Access Compliance Report

Public Rights-of-Way

(Curb Ramps)

Intersection ID: 31582	Main Street: HUGUE_WY	Cross Street: OASIS_LN	Location: W
ADA ID: D7FB00959C34	Ramp Type: Perp	Initial Pass/Fail: Pass	Overall Compliance: No
			Severity Score: 10

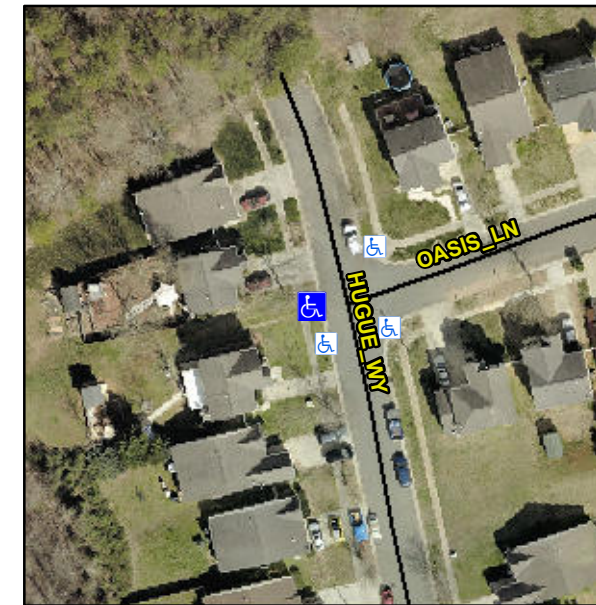
Surveyor Notes:

N/A

Not Found, R304.2.1, R305

Remove & Replace Entire Ramp.
